1733Invention: **TURBINE BRUSH SEAL**I hereby certify that this **Declaration of Wayne F. Reinke Under 37 C.F.R. Section 1.131**

DECLARATION OF WAYNE F. REINKE UNDER 37 C.F.R. §1.131

METHOD, APPARATUS AND SYSTEM FOR CREATING A BRUSH SEAL

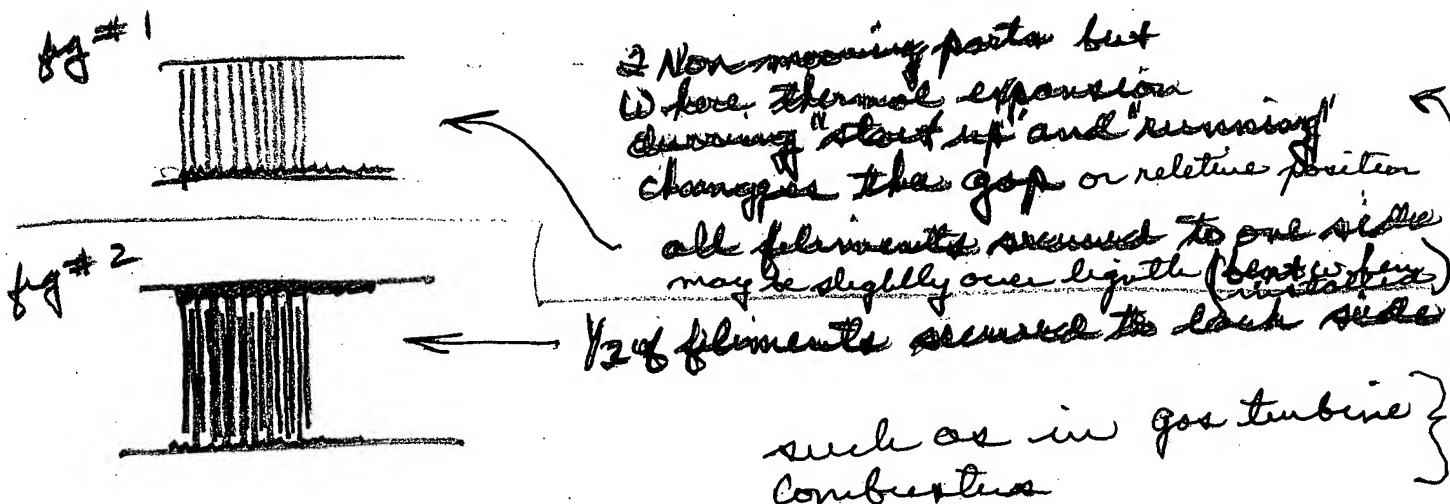
Examples of non-circular cross-sectional flexible filament shapes include various multi-point stars, and squares. ~~shaped with included angles~~ ^{or convex sides} ~~Would be best~~

random orientation of individual filaments relative to each other

actually sharp edges produce more eddies, so you want to make flow as turbulent as possible to minimize flow.

Need
to add
Figure 5

FIG 3

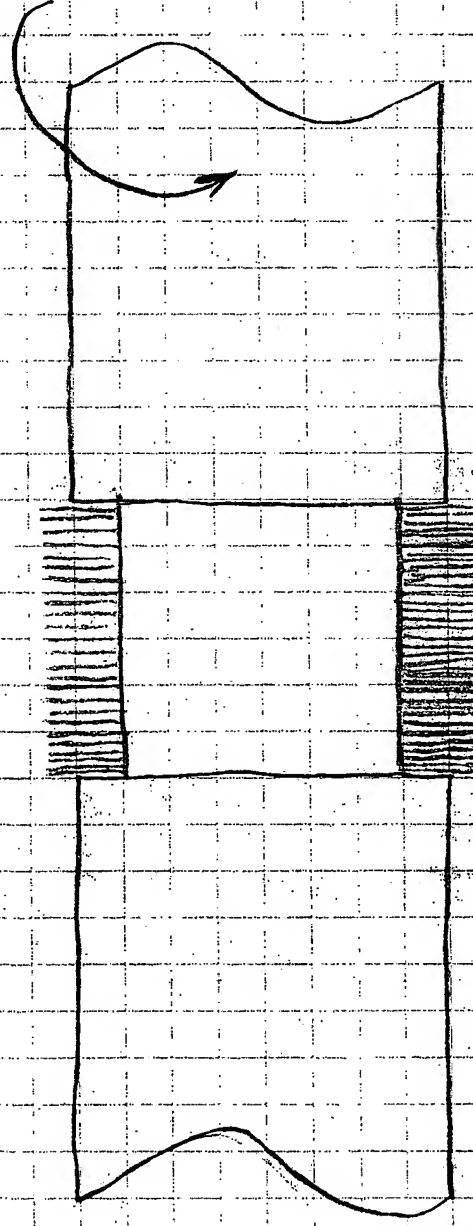
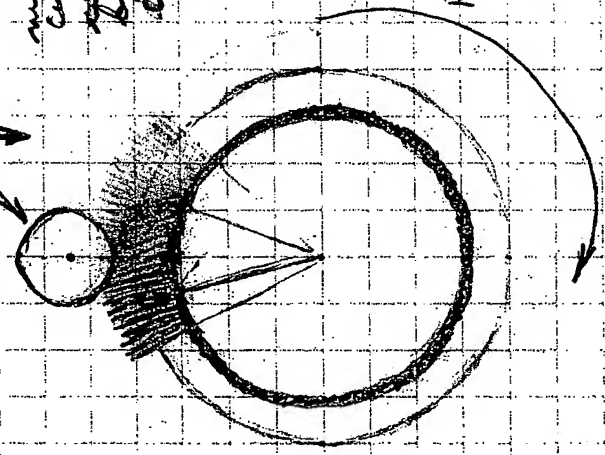
the filaments are held in position in the axial direction while being tipped in the circumferential direction (controls axial spread of filament tips)

FIG. 5

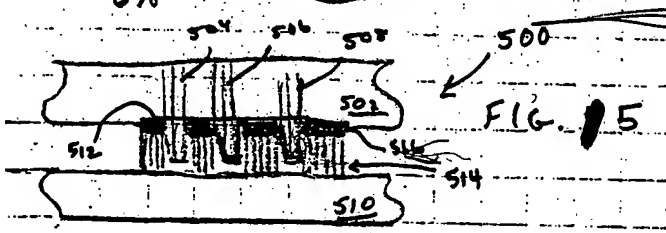
I would put this ahead of the previous idea. It's a better design as it allows for axial movement at the points

make first sample
